Value Engineering

Final Report

Intake Diversion Dam Fish Protection and Passage Concept Design, Lower Yellowstone Project

July 29, 2002

Figure 15. Plan of Wall and Slab Eliminated

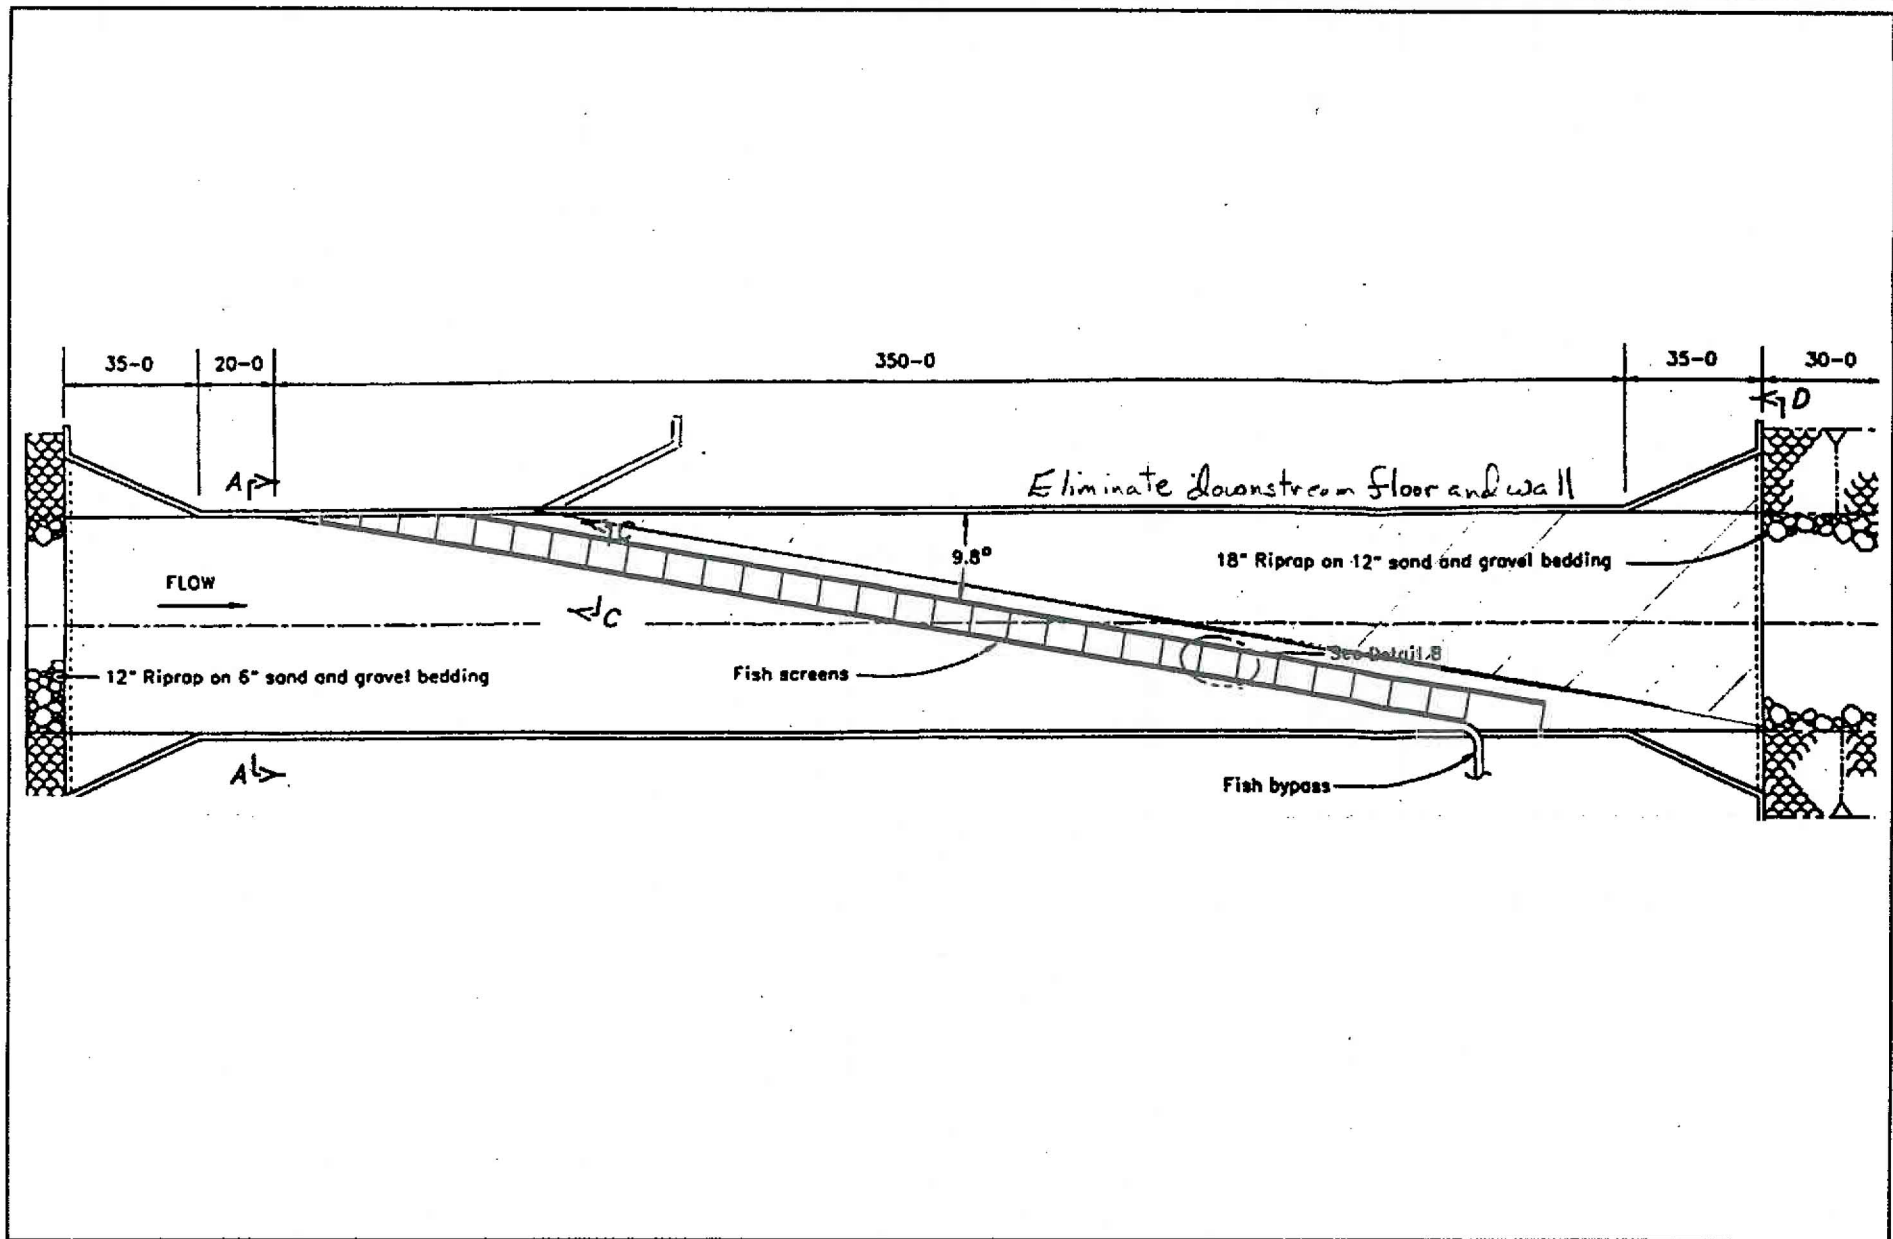
Proposal No. 5. Reduce Concrete in the Fish Screen Structure

- Proposal Description: This proposal would eliminate a section of concrete floor and wall downstream of the fish screens. The left side of the transition at the lower end of the structure would be relocated to just downstream from the upper end of the fish screen. The concrete floor of the canal would be reduced to only that needed for a foundation for the screen structure.
- Critical Items to Consider: Analysis may be performed to determine if bank armor and canal floor riprap are needed to control scour on the downstream side of fish screen.
- Ways to Implement: None noted.
- Changes from the Baseline Concept: This proposal would reduce the area of concrete.

Figure 16. Wall Section

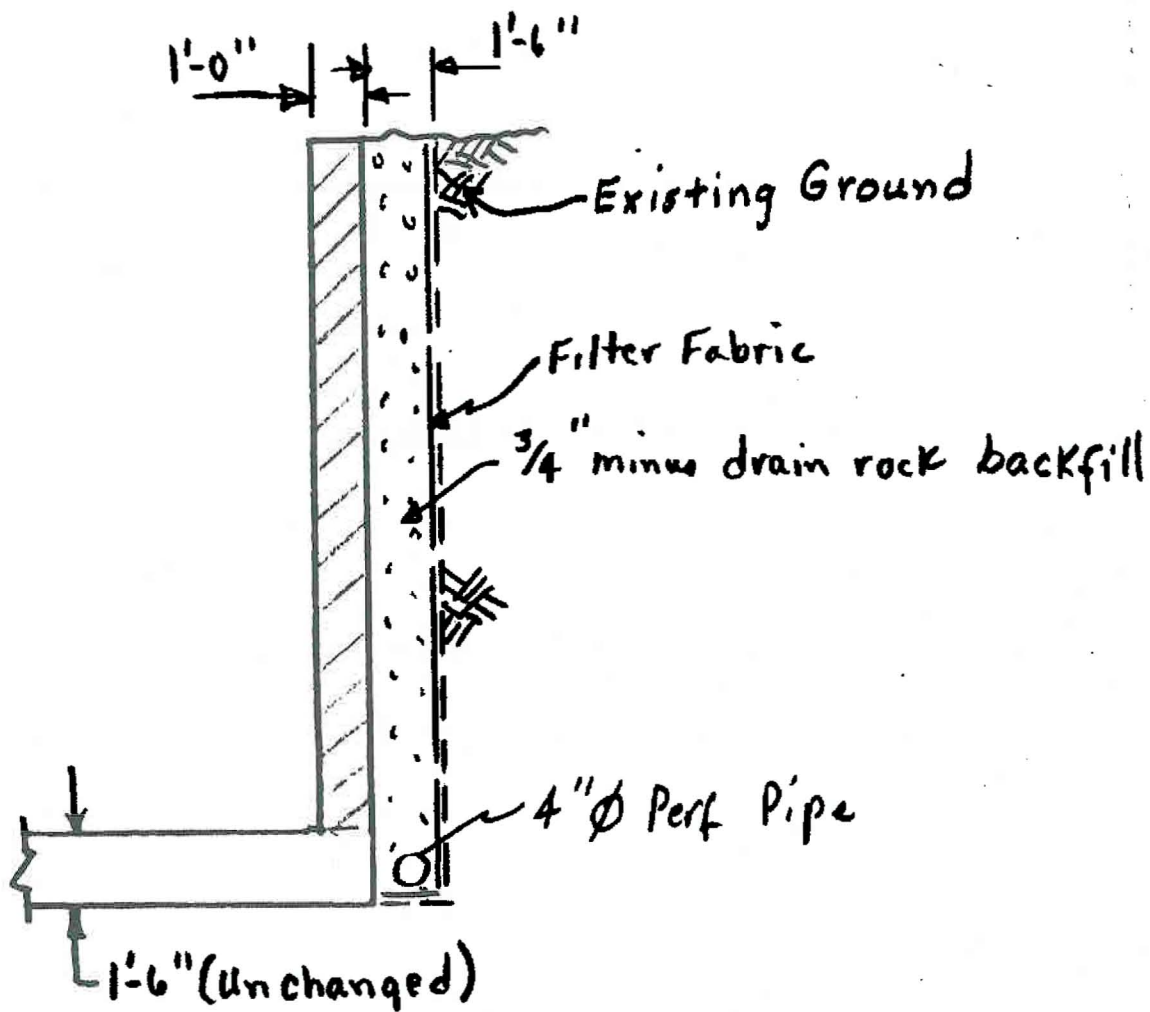
Proposal No. 7. Reduce Screen Structure Wall Thickness.

- **Proposal Description:** This proposal would reduce the thickness of concrete walls from 1 ½-foot to 1-foot. Freeze-thaw problems would be avoided by adding a 1 ½-foot-thick section of drain rock backed by a filter fabric. Water collected between the concrete wall and the filter fabric would drain through a 4-inch perforated pipe at the foot of the wall.

- **Changes from the Baseline Concept:** The major change is the replacement of thicker (1 ½-foot) walls with thinner (1-foot) walls backfilled with a layer of free drain fill and filter fabric. In the climatic conditions encountered at Intake, 1 ½-foot thick concrete is the baseline concept method of addressing freeze-thaw problems. The free drain fill and filter fabric combined with perforated pipe is designed to greatly improve drainage and allow the successful use of the 1-foot thick concrete.

Thickness changed from 1'-6" Base Proposal

Figure 17 Three-Brush Cleaning System Schematic

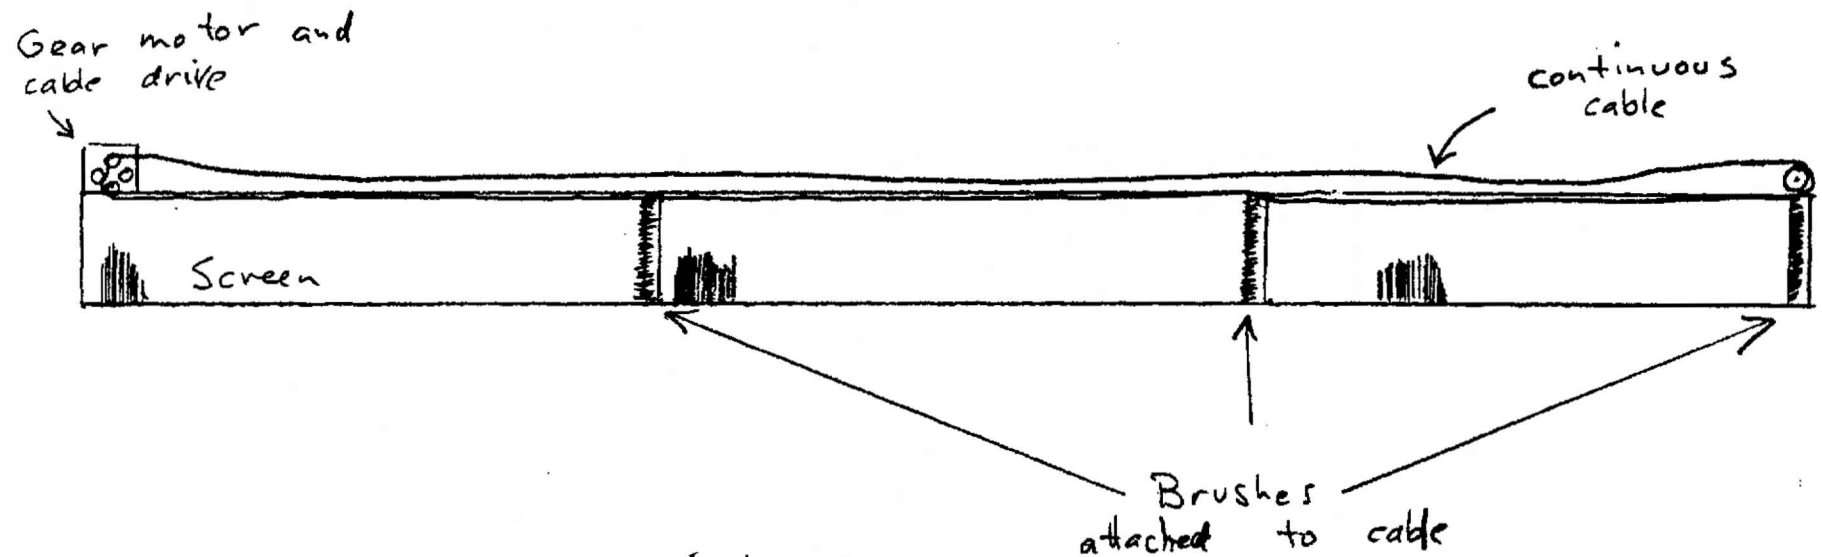
Proposal No. 9. Install a Three-brush Cleaning System in Place of a Single Brush System.

- Proposal Description: With the length of the screen, a multiple brush system will clean the screens more successfully than one brush. With three brushes, screen would be cleaned 12 times per hour versus twice per hour with the base concept. The three brush system is designed for brushing, whereas the single brush system included in the base concept is designed for raking. The three-brush system is less expensive and will provide better cleaning at lower cost.
- Critical Items to Consider: None identified.
- Ways to Implement: A two-brush system or four-brush system could be installed, but three is considered adequate.
- Changes from the Baseline Concept: The change consists of a three-brush system instead of the one-brush system.

- Brushes are held against screen with counter weights
- Brushes operate both directions
- Cable is driven by geared motor and direction is controlled by programmable logic controller and pressure switches
